REPORT AMENDED BY STAFF 7-8-87
CITY PLANNING COMMISSION

- APPLICATION:
- A. Special Permit to allow a 2,310 sq. ft. expansion of an existing church on 0.58 \pm acres in the Single Family (R-1) Zone.
 - B. Variance to waive the required six foot high solid masonry wall requirement separating residential from nonresidential uses.

LOCATION: 3601 - 12th Avenue

PROPOSAL: The applicant is requesting the necessary entitlements to construct a multi-purpose room and dining room of 2,310 sq. ft. onto an existing church.

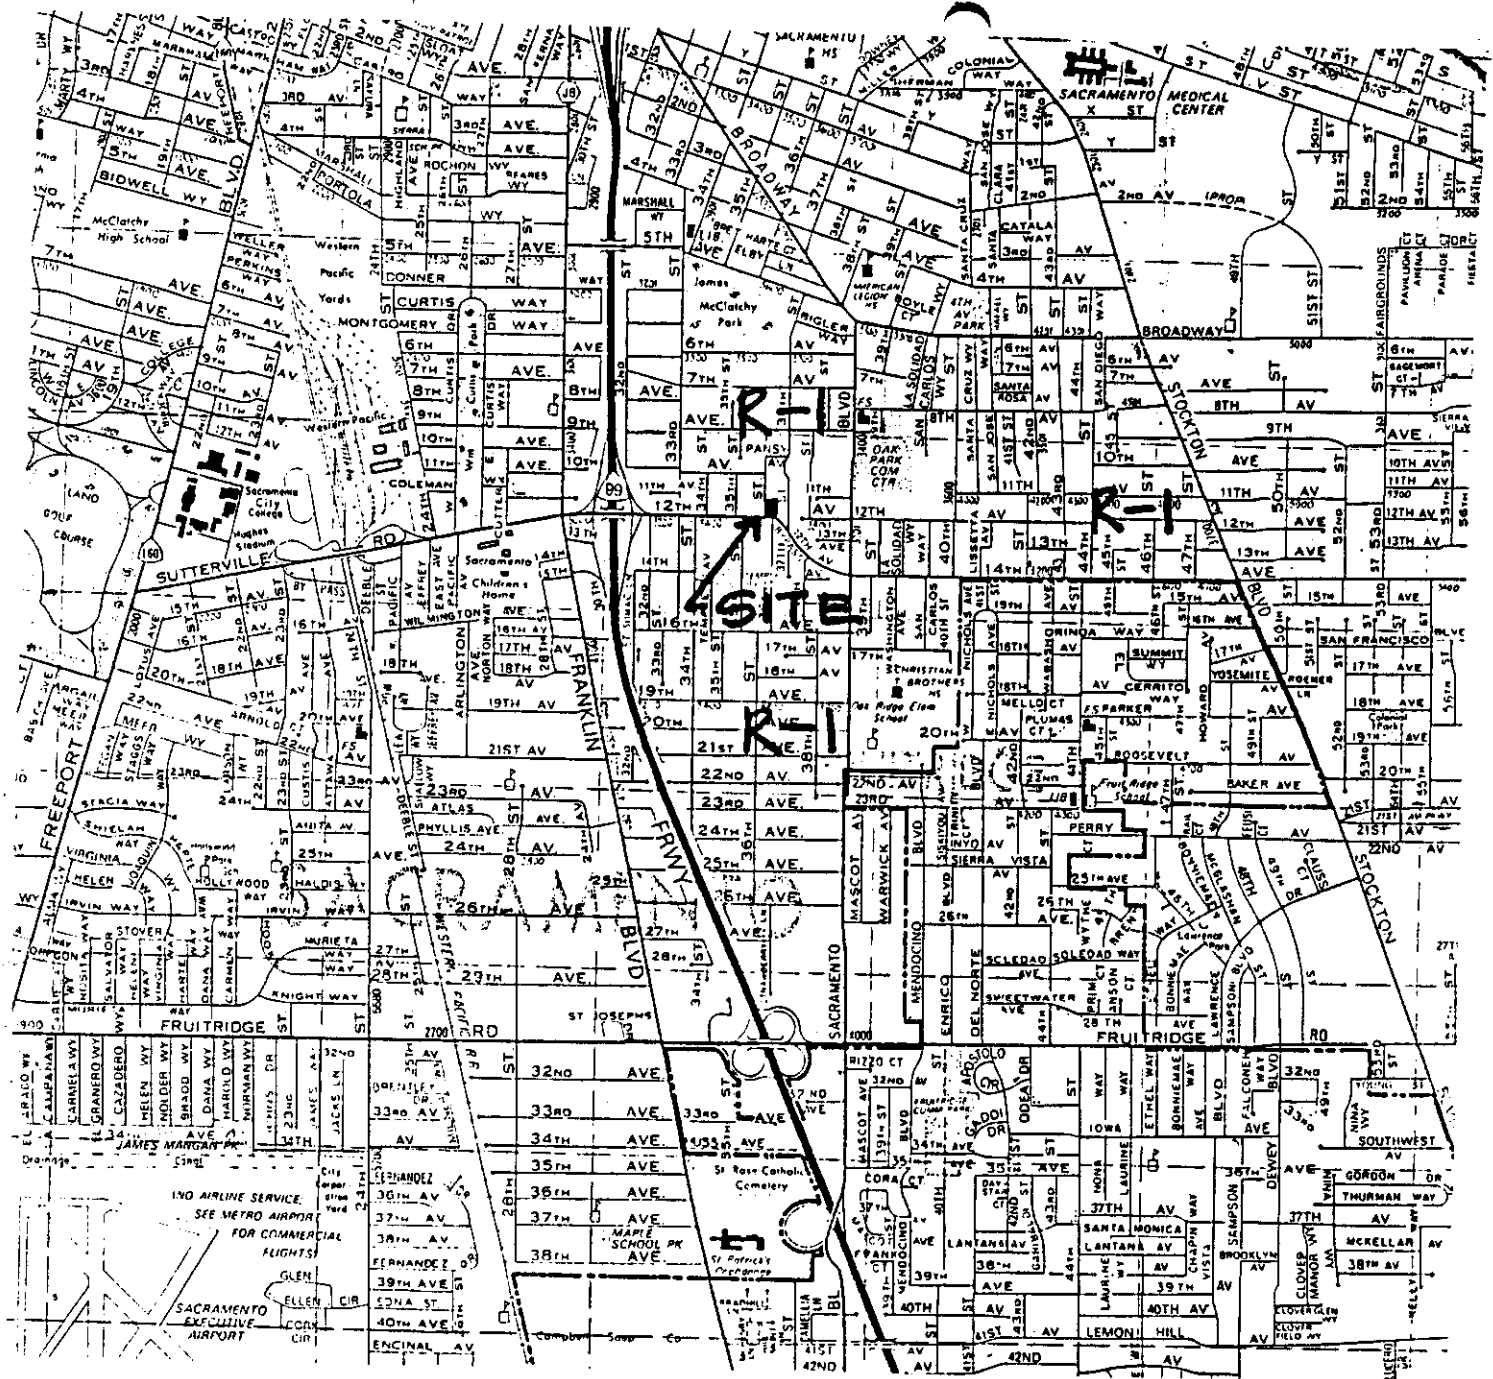
The site plan shows a revised parking lot layout from what currently exists. Staff has the following comments regarding modifications to the parking lot.

1. Increase the number of parking spaces from 26 to 28 spaces so that 164 seats can be used. The present parking lot configuration shows 26 spaces which allows 152 seats in the church.

2. Decrease the length of the parking stalls adjacent to the church and center row from 18 ft. to 16 ft. in length and incorporate a two foot overhang into a landscaped planter. Use of a six inch concrete pour-in-place curb is suggested. Staff does not support use of portable concrete wheel stops. Since the parking lot is paved and does not meet the City Tree Shading Ordinance requirements, staff recommends that the parking lot be broken up by increased planter strips adjacent to the vehicle front ends.

3. Along the north property line, staff recommends a landscape strip of four feet in width with climbing vines adjacent to the chainlink fence in lieu of a solid masonry wall. Staff also recommends the applicant redesign the parking lot to show 90 degree parking along the north property line and increase the number of parking spaces from 7 to 12 along the north line.

4. The east property line currently has a six foot high solid wood fence in very poor condition. In order to prevent vehicles from damaging the fence further, staff recommends the applicant repair the fence and add a two foot planter strip with six inch raised concrete curb to prevent vehicular access to the fence. Currently, one poorly repaired gate to the rear of one of the eastern lots provides access from the parking lot.

5. Staff recommends that the applicant revise the parking lot layout similar to Exhibit A (Staff Modified Site Plan). This includes changing the location of the parking lot light to not reflect onto adjacent residential land uses. A revised parking lot layout plan shall be reviewed and approved by the Planning Director prior to issuance of building permits.

1. The proposed addition and parking lot shall be reviewed and approved by the Design Review Board prior to submittal and issuance of building permits.
2. The applicant shall modify the site plan to reflect items shown on Exhibit A prior to submittal of building permits. This shall include a four foot wide planter along the north parking area and along the south property line. Redesign the southerly parking spaces to 90 degrees. Relocate the pole light or provide a light shield. Add a planter strip along the west property line. Increase the planter width.
3. A trash enclosure meeting the attached trash enclosure guidelines shall be shown on a revised site plan. No unenclosed garbage cans or dumpster bins shall be allowed on the site (see Exhibit B).

4. Detailed landscaping and irrigation plans shall be reviewed and approved prior to issuance of building permits by the Planning Director.
5. Portable concrete wheel stops are not allowed.
6. The applicant shall repair the wood board fence along the east property line adjacent to the parking with the consent of the neighboring property owners. A minimum two foot landscape strip shall be constructed adjacent to the west property line adjacent to the parking area.

ELEVATIONS
SCALE 1/8" = 1'-0"

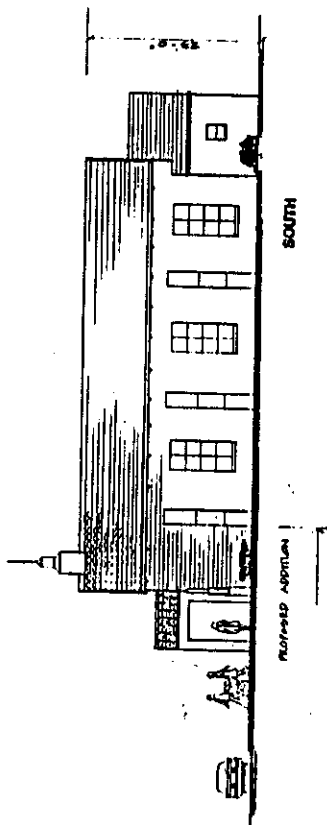
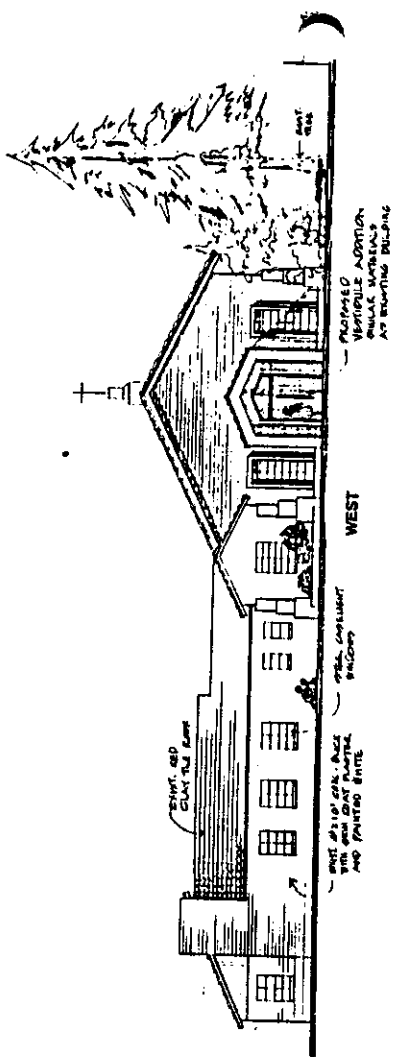
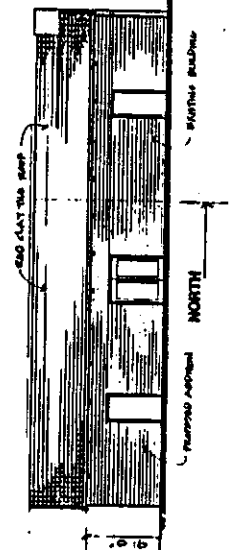
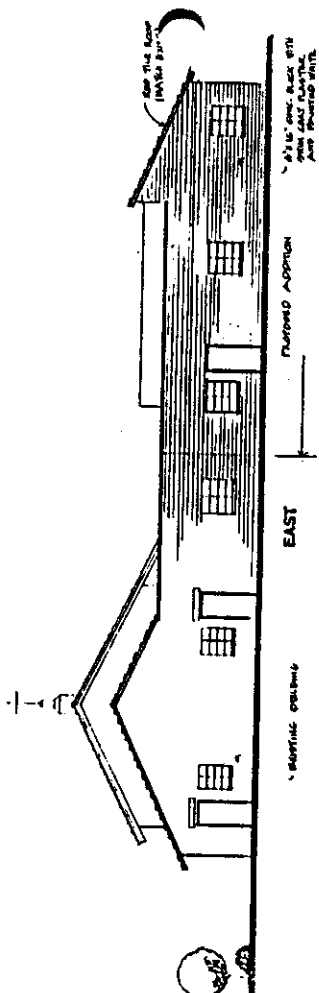
The proposed addition will be architecturally compatible with the existing building. The project is subject to Design Review Board approval since it is located in the Oak Park Design Review District. The rear elevation may require modification to provide variation and relief.
